Union of Concerned Scientists

SUBJECT: Conditional Allegation – Shield Building Design at Davis-Besse

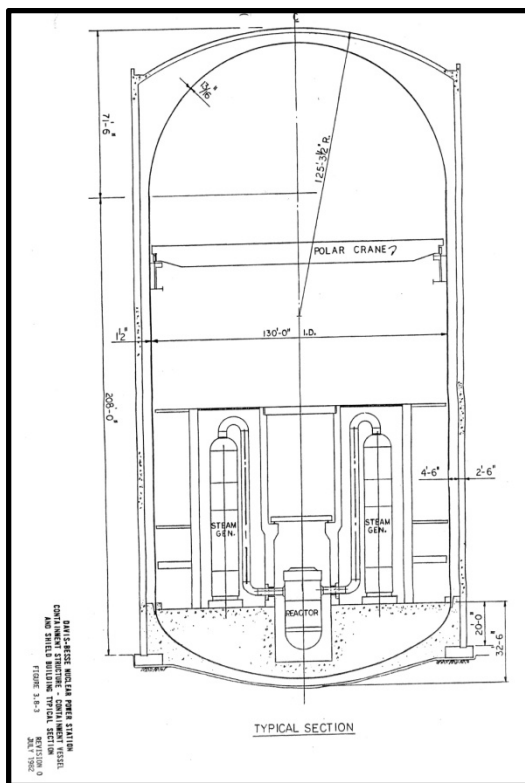
Updated Final Safety Analysis Report (UFSAR) section 3.8.2.2 summarizes the design and associated analyses for the shield building. UFSAR section 3.8.2.2.2 states that dead loads were considered in the shield building design. UFSAR section 3.8.2.2.4 states that the dead loads included concrete (143 pounds per square foot) and steel reinforcing (489 pounds per square foot). UFSAR section 3.8.2.3.7 states that "Cement for all concrete except the Shield Building is Type II low alkali cement ... The Shield Building has Type I cement above grade." UFSAR Figure 3.8-3 (left) illustrates a typical section of the containment vessel and shield building.

1. The “non-structural, architectural concrete” elements do not appear in UFSAR Figure 3.8-3. The plan diagram indicates these elements are connected to the shield building wall. Are the dead loads from these concrete elements properly considered in the design analyses of the shield building?
2. The UFSAR does not explicitly describe these “non-structural, architectural concrete” elements. Thus, it is not clear if these elements have Type II concrete or Type I cement as explained in UFSAR section 3.8.2.3.7. What type of cement was used in the “non-structural, architectural concrete?”
3. If the concrete/cement in the shield building is the same as that in the “non-structural, architectural concrete” elements and all have the same age and environmental exposure history, would numerous cracks identified in one suggest comparable conditions in the other? If not, why not?

UCS realizes that UFSAR Figure 3.8-3 is a simplified drawing and the design analysts hopefully used the more detailed civil/structural arrangement drawings, but it is prudent to check to verify

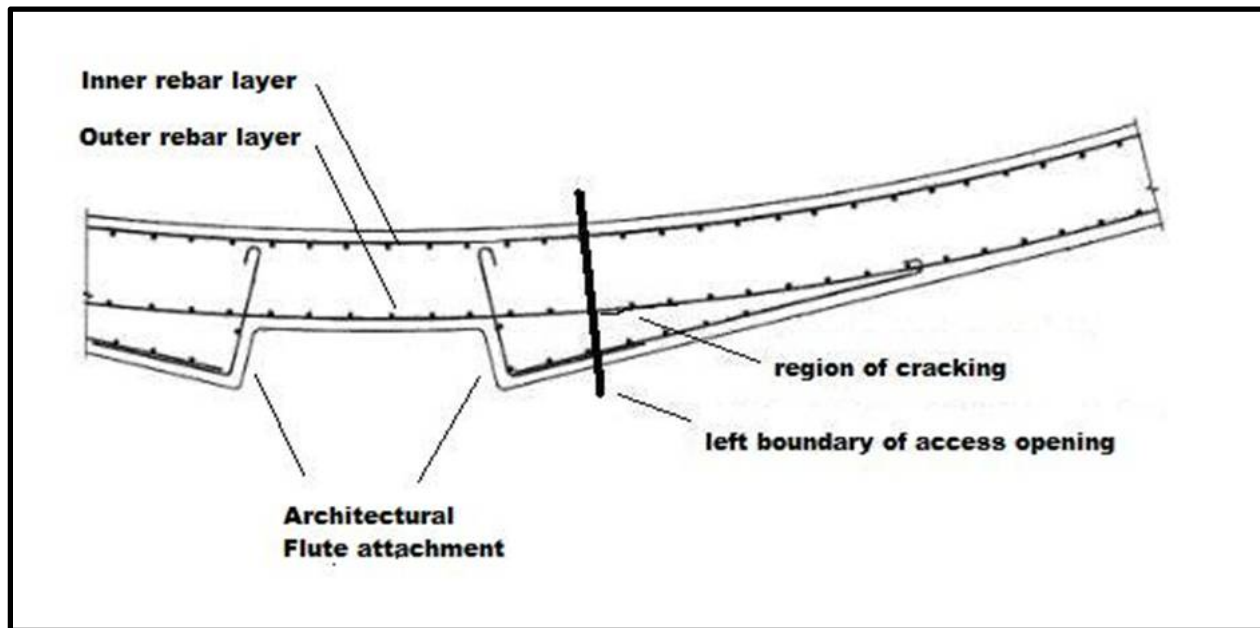
This plan diagram (overhead view) of a section of the shield building wall shows the “non-structural, architectural concrete” referred to in the NRC’s PNO. As indicated by the two fish-hook shaped devices in the drawing, the attachments are anchored to the shield building wall.

1. The design evaluation and analysis for the shield building did not properly consider the dead load from the "non-structural, architectural concrete" attached to it.
2. The shield building wall was not sufficiently examined for indication of cracking.
